SERVICE BULLETIN

N° **139-522**

**ATA 95 - INSTALLATION OF COCKPIT AND CABIN PASSENGER FLOOR BALLISTIC PROTECTIONS**

To provide all necessary instructions on how to perform the installation of the kit cockpit floor ballistic protection P/N 4G9580F00311, kit cockpit door ballistic protection P/N 4G9580F00411 and kit cabin passenger floor ballistic protection P/N 4G9580F00911.

Figure 12

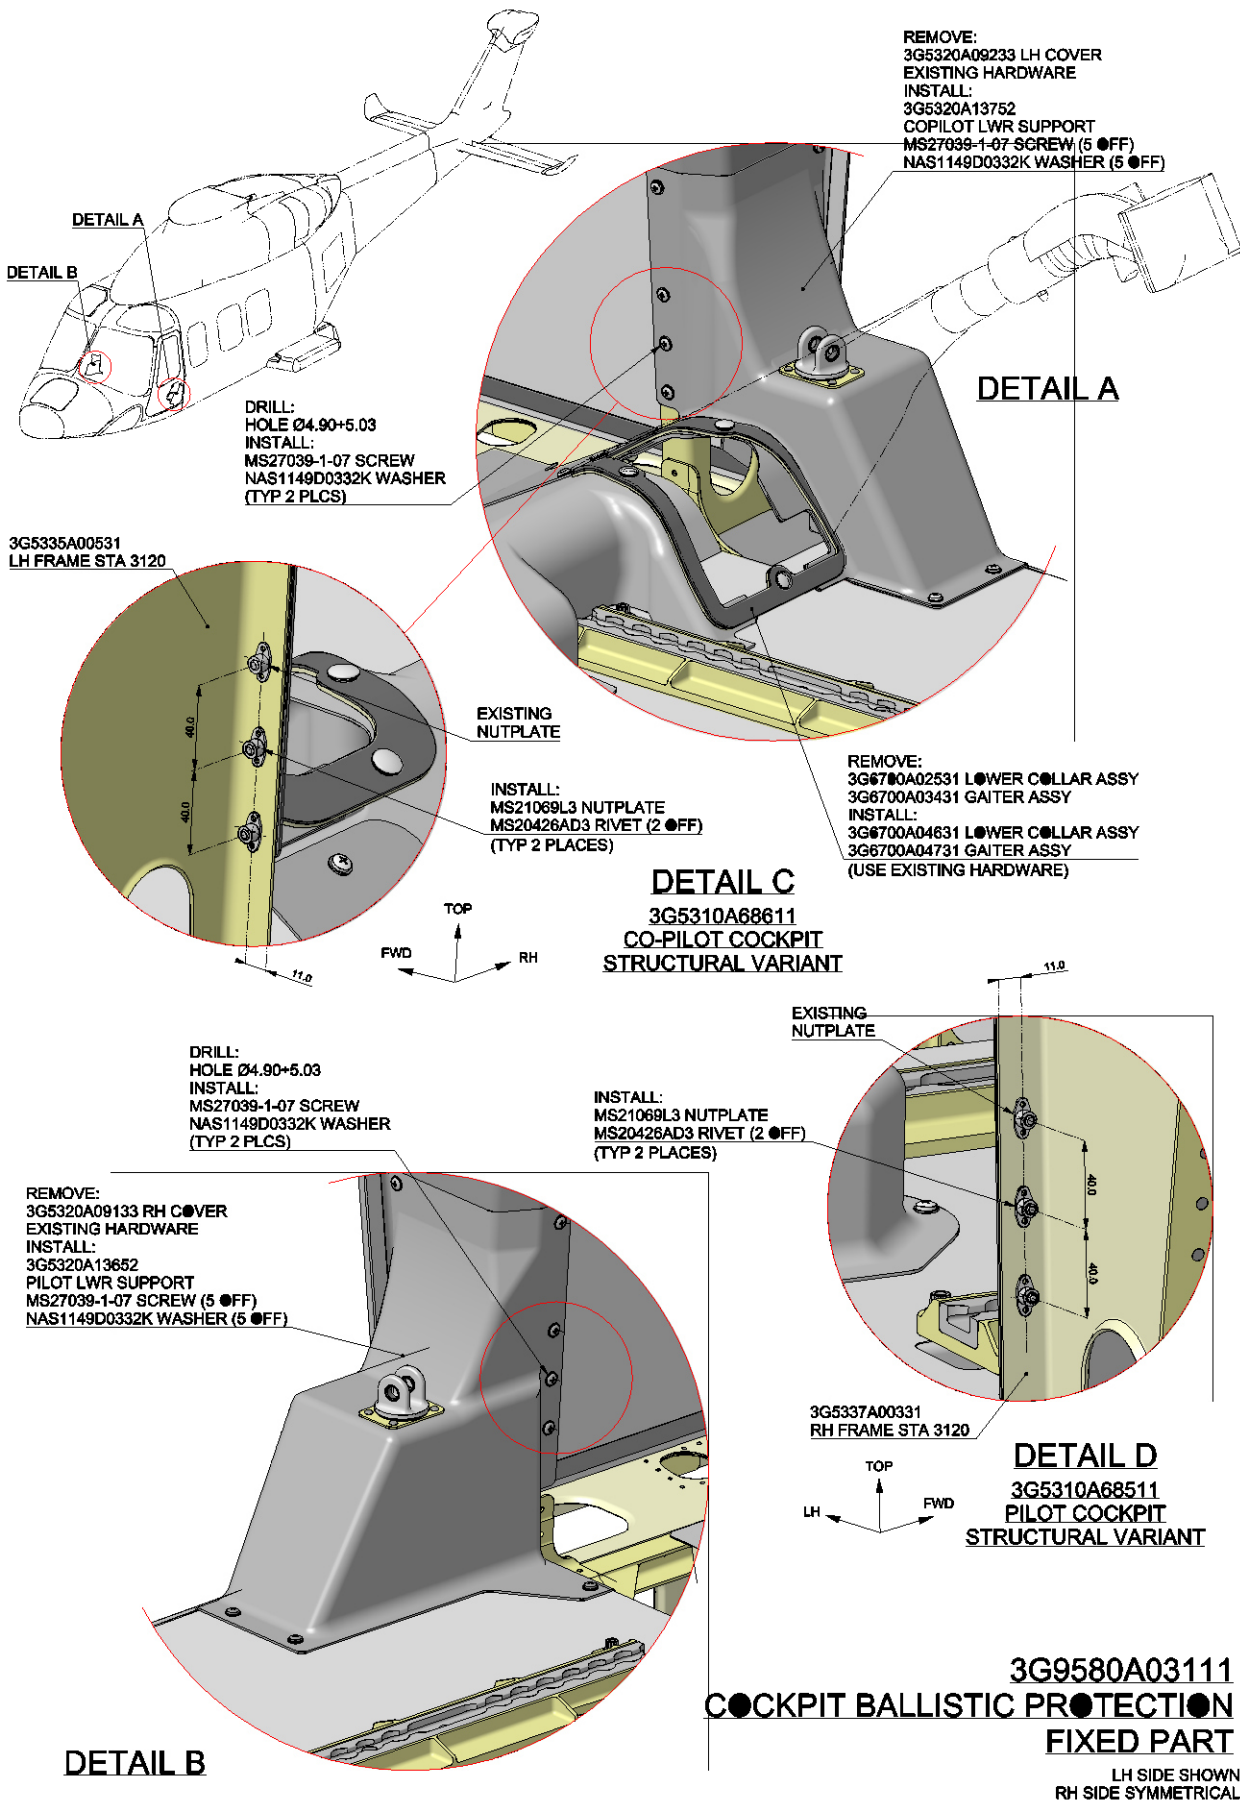
- 2.2.1 With reference to Figure 12 Detail A, remove the existing gaiter assy P/N 3G6700A02531 and collar P/N 3G6700A03431 from the cockpit. Store the hardware for later re-use.

- 2.2.8 With reference to Figure 12 Detail C, install n°2 nutplates P/N MS21069L3 in the indicated positions by means of n°4 rivets P/N MS20426AD3.
- 2.2.9 With reference to Figure 12 Detail A drill n°2 holes Ø4.8 thru co-pilot lower support P/N 3G5320A13652, coordinating with hole positions on structure.

- 2.2.10 With reference to Figure 12 Detail, temporarily install the co-pilot lower support P/N 3G5320A13652 by means of n°7 screws P/N MS27039-1-07 and n°7 washers P/N as1149D0332K.

- 2.3 Perform pilot cockpit structural variant P/N 3G5310A68511 as described in the following procedure:
  - 2.3.1 With reference to Figure 12 Detail A, remove the indicated LH cover P/N 3G5320A09133 from the cockpit.

- 2.3.7 With reference to Figure 12 Detail D, install n°2 nutplates P/N MS21069L3 in the indicated positions by means of n°4 rivets P/N MS20426AD3.
  - 2.3.8 With reference to Figure 12 Detail B drill n°2 holes Ø4.8 thru pilot lower support P/N 3G5320A13752, coordinating with hole positions on structure.

2. Perform the cockpit ballistic protection fixed parts installation P/N 3G9580A03111 as described in the following procedure:
  - 2.1 With reference to Figure 12 Detail A, remove the existing gaiter assy P/N 3G6700A02531 and collar P/N 3G6700A03431 from the cockpit.

- 2.2 With reference to Figure 12 Detail A, remove the indicated LH cover P/N 3G5320A09233 from the cockpit.
  - 2.3 With reference to Figure 12 Detail A, install the co-pilot lower support P/N 3G5320A13652 by means of n°7 screws P/N MS27039-1-07 and n°7 washers P/N as1149D0332K.

- 2.4 With reference to Figure 12 Detail A, install the new gaiter assy P/N 3G6700A04731 and collar P/N 3G6700A04631 by means of existing hardware.
  - 2.5 With reference to Figure 14 Detail EB, remove the cover LH P/N 3G5330A14053 and install the upper support LH P/N 3G5330A28731 and relevant shim P/N 3G9580A02551 by means of n°2 bolts P/N AN3-5A and n°2 washers P/N NAS1149D0332K.

- 2.7 With reference to Figure 12 Detail B, remove the indicated RH cover P/N 3G5320A09133 from the cockpit.
  - 2.8 With reference to Figure 12 Detail B, install the pilot lower support P/N 3G5320A13652 by means of n°7 screws P/N MS27039-1-07 and n°7 washers P/N as1149D0332K.

**Figure 13**

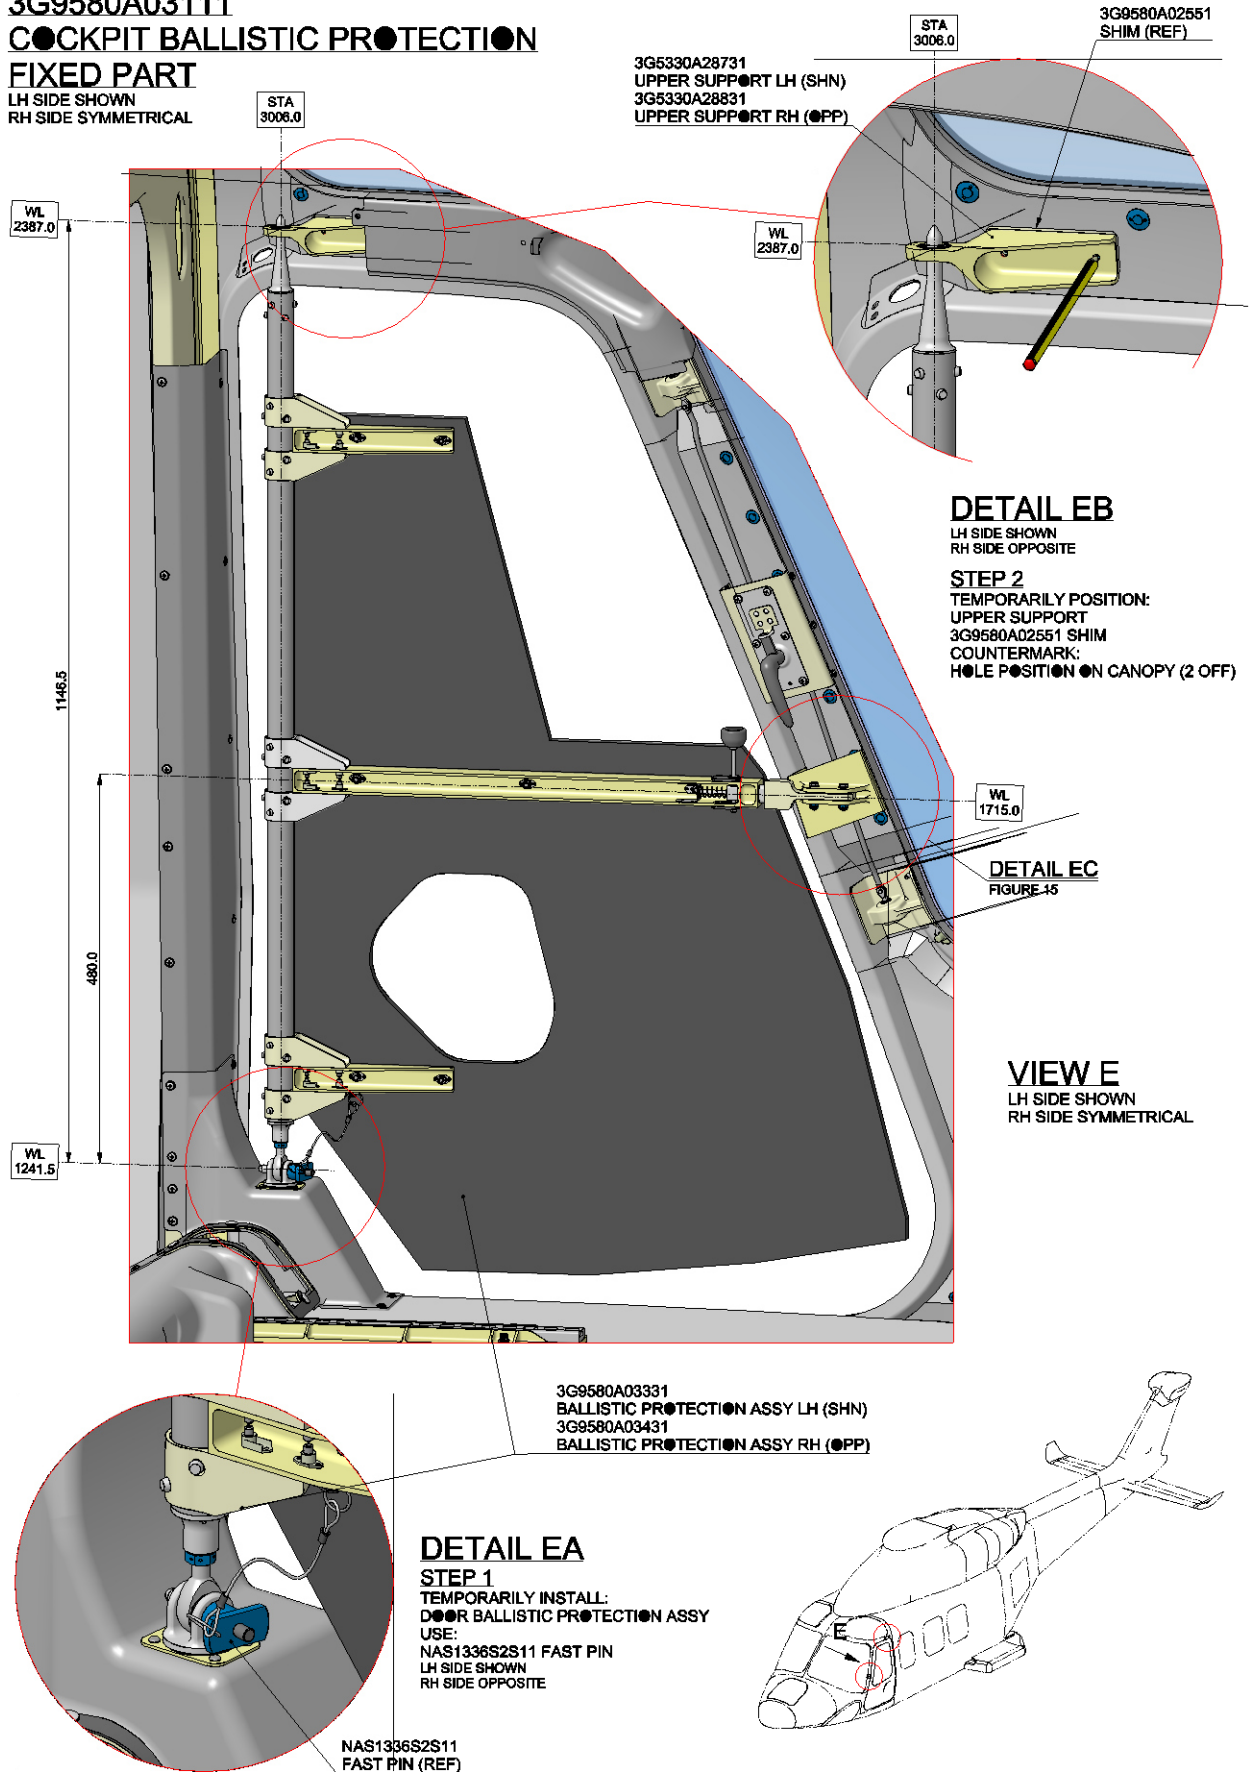
- 2.2.11 With reference to Figure 13 Detail EA, temporarily install the door ballistic protection assy LH P/N 3G9580A03331 by means of fast pin P/N NAS1336S2S11.

- 2.3.10 With reference to Figure 13 Detail EA, temporarily install the door ballistic protection assy RH P/N 3G9580A03431 by means of fast pin P/N NAS1336S2S11.

- 2.4.2 With reference to Figure 13 Detail EA, temporarily install the door ballistic protection assy LH P/N 3G9580A03331 by means of fast pin P/N NAS1336S2S11.

Figure 14

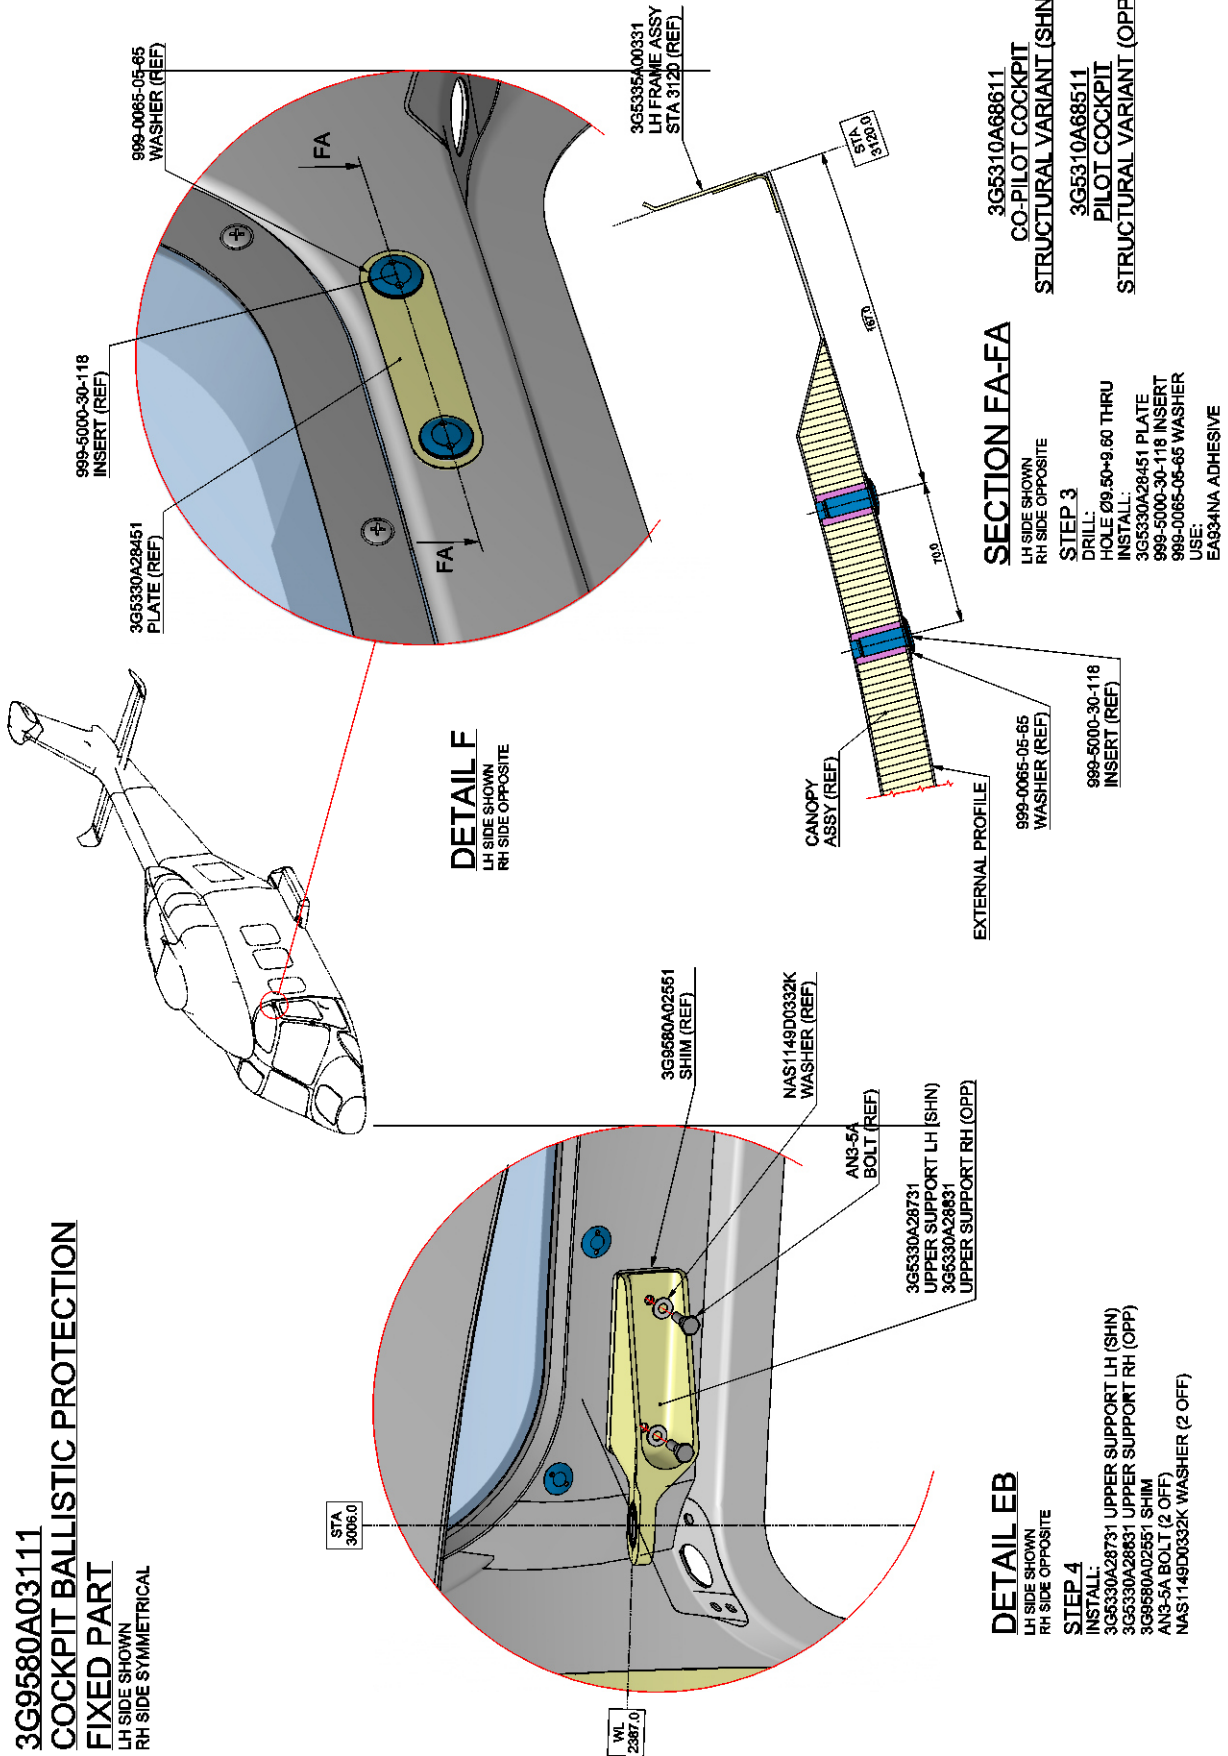
- 2.2.14 With reference to Figure 14 Detail EB, temporarily position the upper support LH P/N 3G5330A28731 and relevant shim P/N 3G9580A02551 in the final installation position; countermark the n°2 hole positions on canopy structure.

- 2.2.15 Remove the door ballistic protection assy LH P/N 3G9580A03331 and relevant fast pin P/N NAS1336S2S11.
- 2.2.16 With reference to Figure 14 Detail F and Section FA-FA, drill n° 2 holes Ø9.50÷9.60 thru external skin and core of canopy and install a plate P/N 3G5330A28451 by means of n°2 inserts P/N 999-5000-30-118 and washers P/N 999-0065-05-65; use adhesive EA934NA for inserts installation.

- 2.3.13 With reference to Figure 14 Detail EB, temporarily position the upper support RH P/N 3G5330A28831 and relevant shim P/N 3G9580A02551

- 2.3.15 With reference to Figure 14 Detail F and Section FA-FA, drill n° 2 holes  $\varnothing 9.50 \div 9.60$  thru external skin and core of canopy and install a plate P/N 3G5330A28451 by means of n°2 inserts P/N 999-5000-30-118 and washers P/N 999-0065-05-65; use adhesive EA934NA for inserts installation.

- 2.4.1 With reference to Figure 14 Detail EB, temporarily install the upper support LH P/N 3G5330A28731 and relevant shim P/N 3G9580A02551 by means of n°2 bolts P/N AN3-5A and n°2 washers P/N NAS1149D0332K.

- 2.4.21 With reference to Figure 14 Detail EB, remove the upper support LH P/N 3G5330A28731, the shim P/N 3G9580A02551, n°2 bolts P/N AN3-5A and n°2 washers P/N NAS1149D0332K temporarily installed.

Figure 15

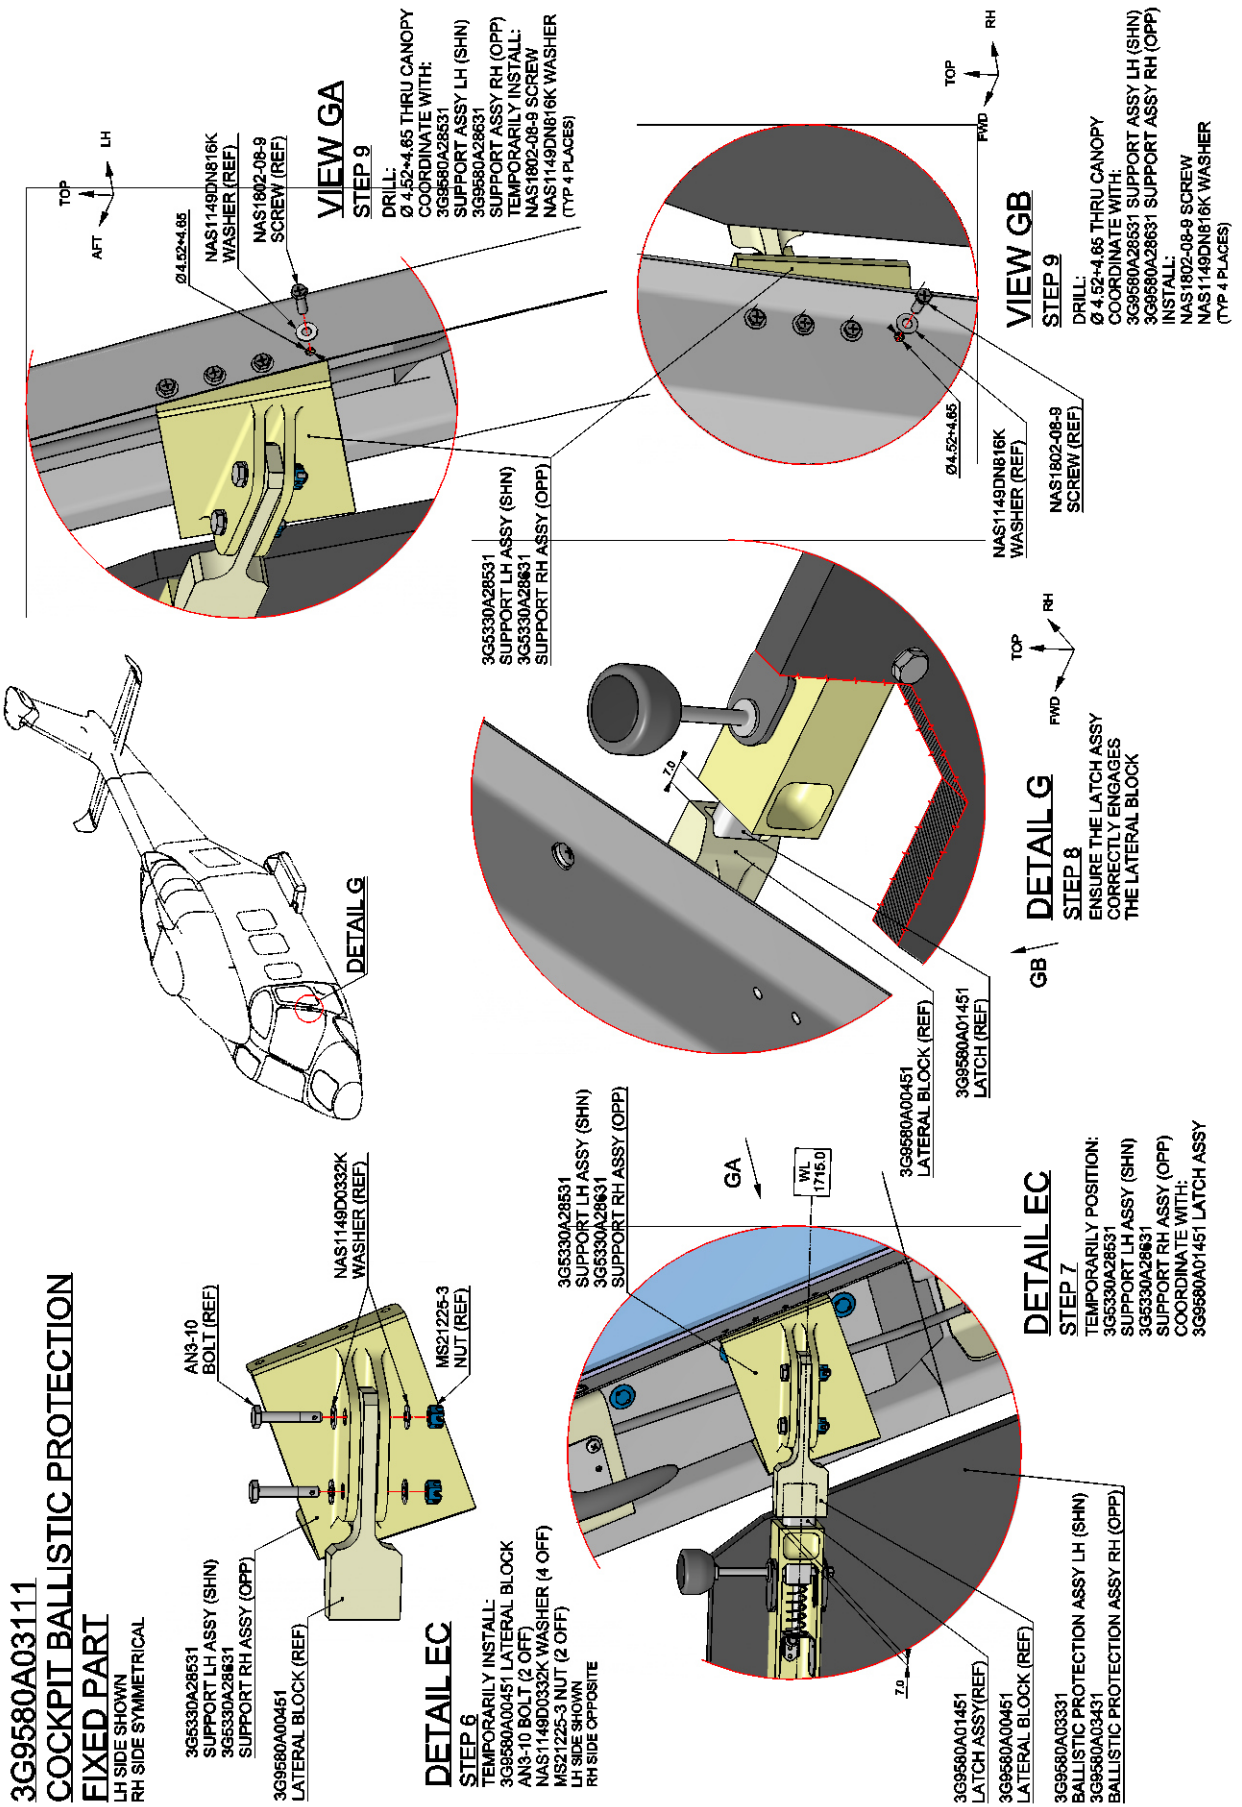
- 2.4.3 With reference to Figure 15 Detail EC (STEP 6), temporarily install the lateral block P/N 3G9580A00451 on the support assy LH P/N 3G5330A28531 by means of n°2 bolts P/N AN3-10, n°4 washers P/N NAS1149D0332K and n°2 nut P/N MS21225-3.

- 2.4.4 With reference to Figure 15 Detail EC (STEP 7), temporarily position the support assy LH P/N 3G5330A28531 in its installation position in the canopy assy (WL 1715.0).

- 2.4.5 With reference to Figure 15 Detail G, ensure the door latch assy correctly engages the lateral block then countermark on the canopy the position of n°8 installation holes from the support assy LH P/N 3G5330A28531.

- 2.4.6 Remove the door ballistic protection assy LH P/N 3G9580A03331 and relevant fast pin P/N NAS1336S2S11.
  - 2.4.7 With reference to Figure 15 Details GA and GB, drill n°8 holes  $\varnothing 4.52 \div 4.65$  thru the canopy.

- 2.4.8 With reference to Figure 15 Details GA and GB, temporarily install the support assy LH P/N 3G5330A28531 by means of n°8 screws P/N NAS1802-08-9 and n°8 washers P/N NAS1149DN816K.

- 2.4.23 With reference to Figure 15 Details GA and GB, remove the support assy LH P/N 3G5330A28531, n°8 screws P/N NAS1802-08-9 and n°8 washers P/N NAS1149DN816K temporarily installed.

- 2.6 With reference to Figure 15 Details GA and GB, remove the pilot cover LH P/N 3G5330A13851 and install the support assy LH P/N 3G5330A28531 by means of n°8 screws P/N NAS1802-08-9 and n°8 washers P/N NAS1149DN816K.

- 2.10 With reference to Figure 15 Details GA and GB, remove the pilot cover RH P/N 3G5330A13951 and install the support assy RH P/N 3G5330A28631 by means of n°8 screws P/N NAS1802-08-9 and n°8 washers P/N NAS1149DN816K.
